HISTORIC AND DESIGN REVIEW COMMISSION

September 04, 2019

HDRC CASE NO: 2019-491
ADDRESS: 527 E HUISACHE AVE
525 E HUISACHE AVE
LEGAL DESCRIPTION: NCB 3090 BLK 6 LOT 26
ZONING: MF-33,H
CITY COUNCIL DIST.: 1
DISTRICT: Monte Vista Historic District
APPLICANT: David Bogle/SYNCRO Studio
OWNER: Grant Garbo
TYPE OF WORK: Construction of a rear addition, site modifications, exterior modifications, window replacement
APPLICATION RECEIVED: August 16, 2019
60-DAY REVIEW: October 15, 2019
CASE MANAGER: Stephanie Phillips
REQUEST:

SK - 25

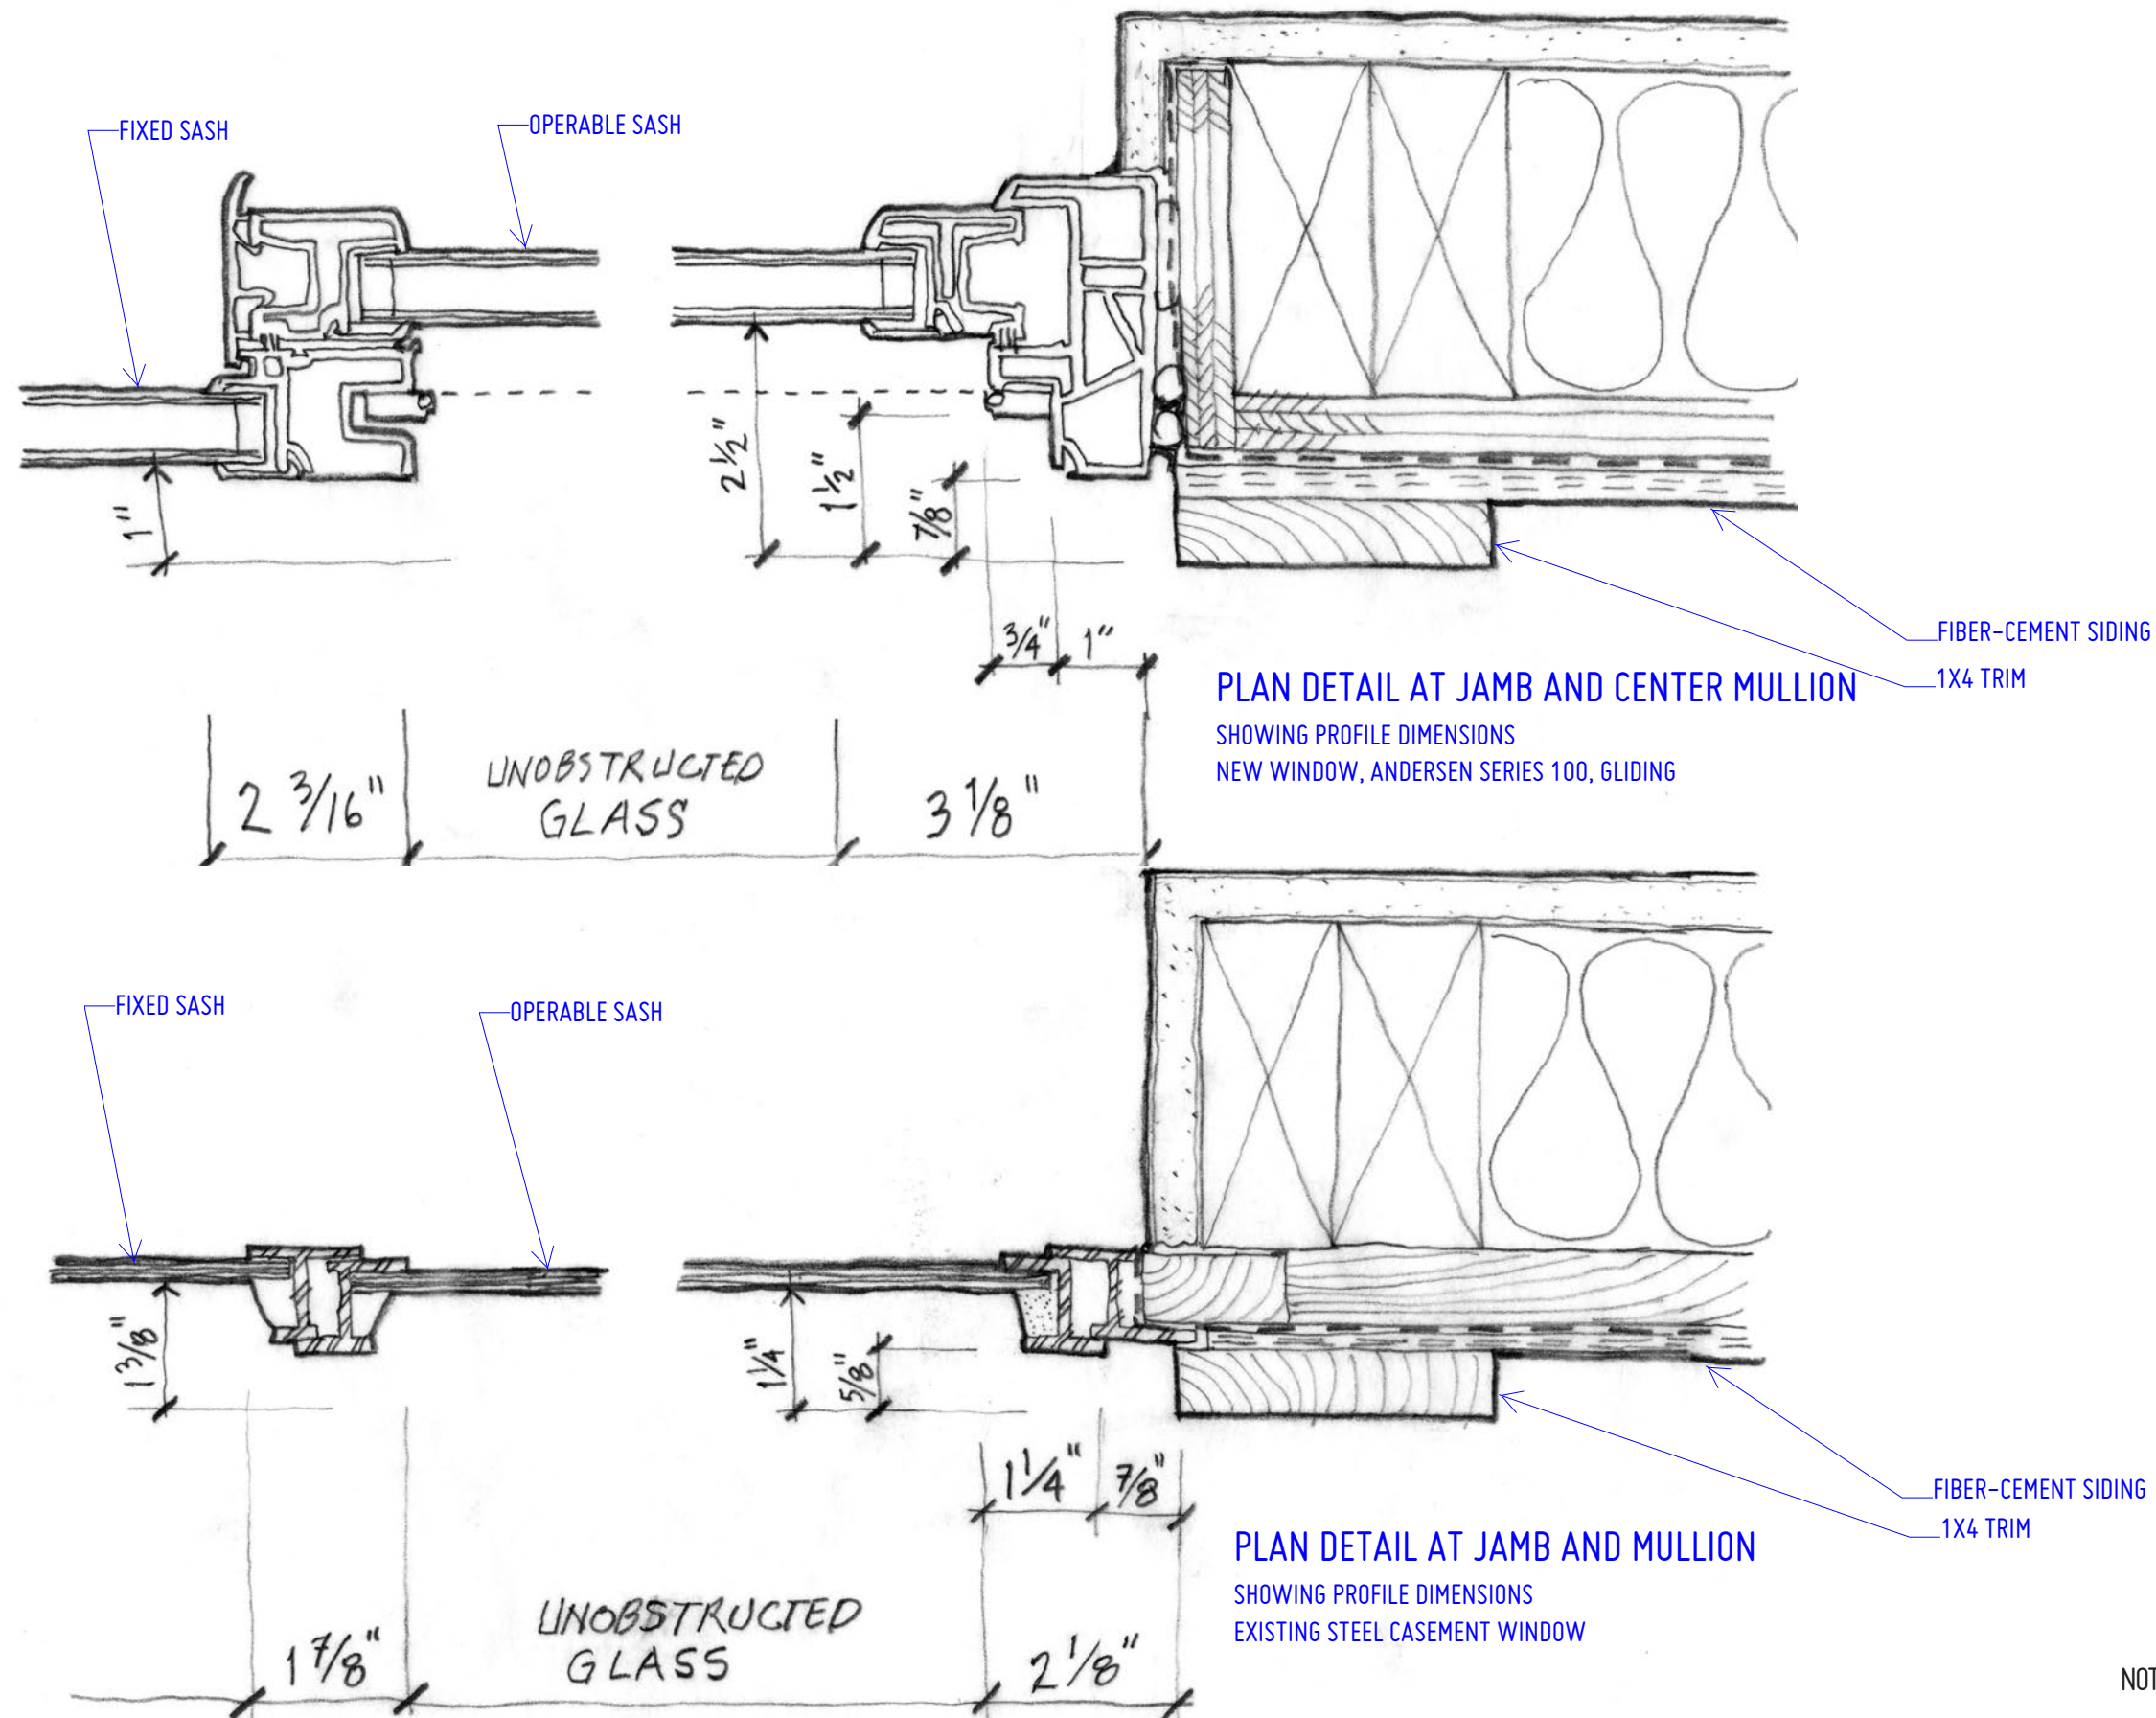
- d. WINDOW REPLACEMENT – The applicant has proposed to replace two existing casement windows on the east and west facades with new composite sliding windows. The Historic Design Guidelines state that existing original openings should be preserved on the historic structure. Staffs finds that the original casement windows should be restored and remain in place.

Item 1, Staff does not recommend approval of the replacement of the casement windows based on finding d.
